TAB F: FIVE DRAFT ENVIRONMENTAL IMPACT STATEMENT ALTERNATIVES (2007 –2008)

DEIS Errata and Clarifications

Last updated: May 21, 2008

The following corrects errors in the I-5 Columbia River Crossing (CRC) Draft Environmental Impact Statement (DEIS) that was released for public review and comment on May 2, 2008. The Draft EIS will be further updated as errors are discovered or to clarify points of confusion. Such updates or corrections will be made either with additional errata or in the Final EIS anticipated to be released in summer 2009.

Exhibit 14 (page 2 of 2) Transit Terminus and Alignment Options for Alternative 4

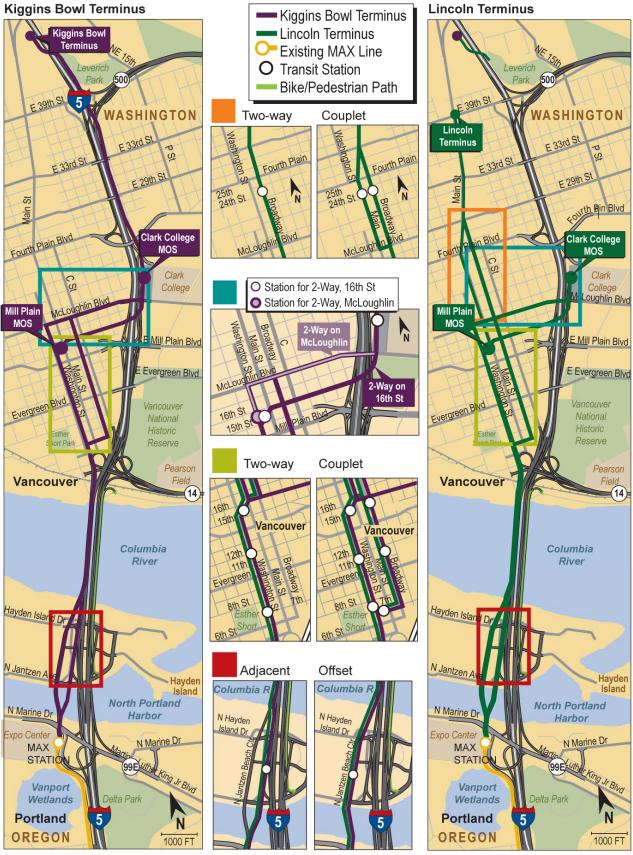
Summary	15	Exhibit 14: Adjacent inset shows N Jantzen Beach Ctr extending over North Portland Harbor	This crossing over North Portland Harbor does not exist, nor is it a CRC project alternative
Summary	17	Exhibit 15: Adjacent inset shows N Jantzen Beach Ctr extending over North Portland Harbor	This crossing over North Portland Harbor does not exist, nor is it a CRC project alternative
Summary	20	Exhibit 17: Key for Detailed Area of River Crossing displays a "3" in the colored label boxes corresponding with northbound and southbound through and auxiliary lanes.	The "3" was chosen to make the key consistent and is not meant to imply that there would be three through and three auxiliary lanes in both directions. Please refer to the graphic to the left of key for the actual number of lanes over the river crossing. The type of lane (i.e., northbound or southbound, through or auxiliary) is denoted by the color of the label box.

Exhibit 18 Supplemental River Crossing

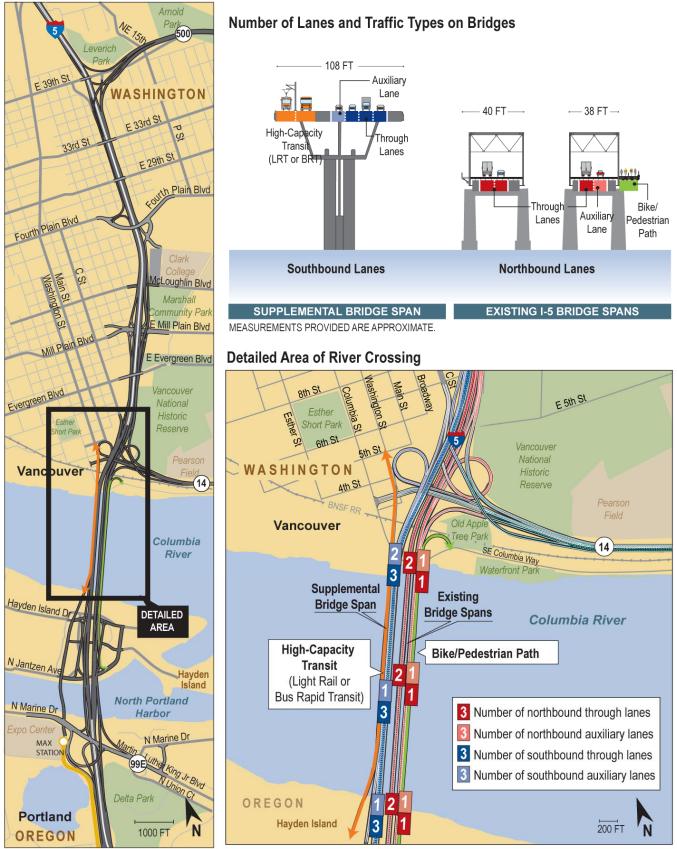
Summary	21	Exhibit 18: Key for Detailed Area of River Crossing displays a "3" in the colored label boxes corresponding with northbound and southbound through and auxiliary lanes.	The "3" was chosen to make the key consistent and is not meant to imply that there would be three through and three auxiliary lanes in both directions. Please refer to the graphic to the left of key for the actual number of lanes over the river crossing. The type of lane (i.e., northbound or southbound, through or auxiliary) is denoted by the color of the label box.
Summary	23	Exhibit 21 states "two-way Broadway" in the legend for a downtown Vancouver transit alignment option	Two-way <u>Washington</u>
Summary	23	Exhibit 21 shows the two-way Broadway alignment option in northern Vancouver on Main Street	This alignment option should be shown on Broadwa
